Re: Review of Watercourse Constraint Ranking for Watercourse Reaches 'C-1' and

'C-2', Vision Georgetown Secondary Plan Area, Town of Halton Hills

Re: Vision Georgetown - Tributary C Realignment Alternative near 10512 8th Line

Re: Vision Georgetown (South) Subwatershed Study and Secondary Plan, Tributary C Management – Constraint Ranking and Realignment Alternatives

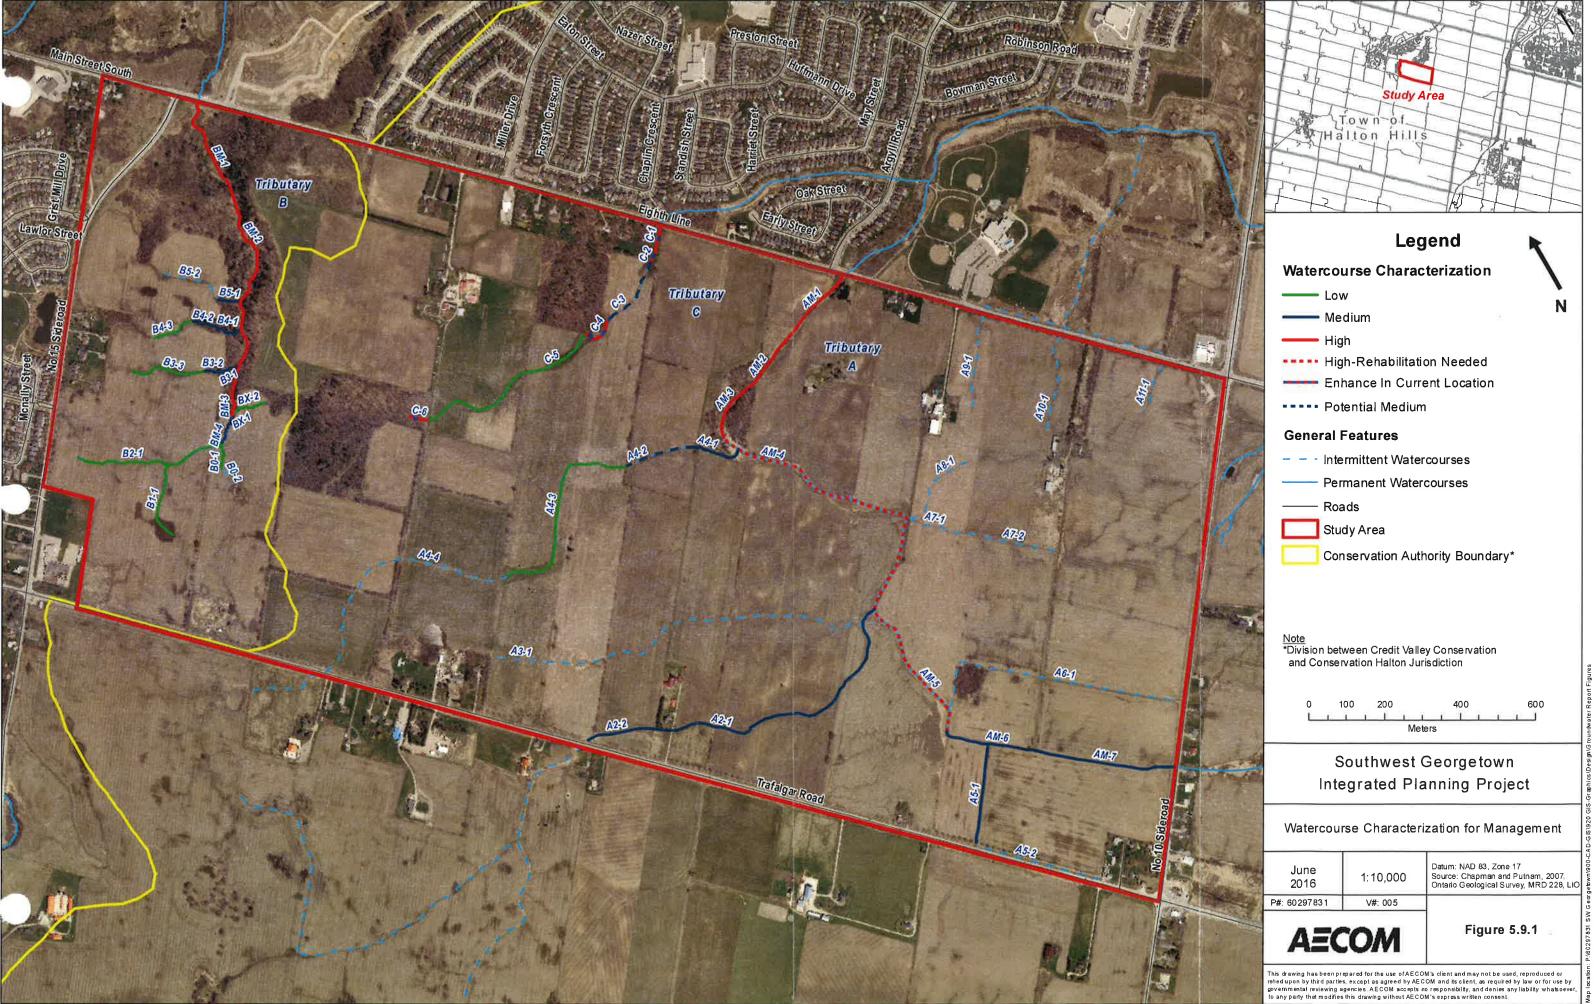
However, recognizing that the features are located within a lawn that is frequently maintained (ref. AECOM 2017, Appendix I), watercourse reaches 'C1' and 'C2' are considered to be subject to frequent disturbance as part of the routine lawn maintenance by the property owner. Furthermore, the 100m total reach length of watercourse reaches 'C1' and 'C2' are noted to be relatively small and further represent a low portion of Tributary 'C' which has been classified as a "Low" constraint watercourse, hence is considered to provide limited benefit to the flooding and conveyance system of the Vision Georgetown Area and the contributing drainage areas to the reach. In this regard, it is noteworthy that a similar situation was identified during the watercourse

constraint ranking completed for the Boyne Survey Area in the Town of Milton as part of the Sixteen Mile Creek Subwatershed Update Study (ref. Amec et. al., November 2015). In that instance, it was ultimately agreed that a "Low" constraint ranking was appropriate for the full length of the subject watercourse (ref. Boyne Survey Area watercourse SE-2-D-1) upstream of Britannia Road and was applied accordingly.

Given the relatively small drainage area to the watercourse reaches, the frequent disruption of the feature due to lawn maintenance of the property, and the limited benefit derived from protecting the reach as an open feature for flooding and conveyance, we concur with the "Low" constraint ranking for the surface water component of watercourse reaches 'C1' and 'C2', as advanced in the May 2017 Subwatershed Study for the Vision Georgetown Area.
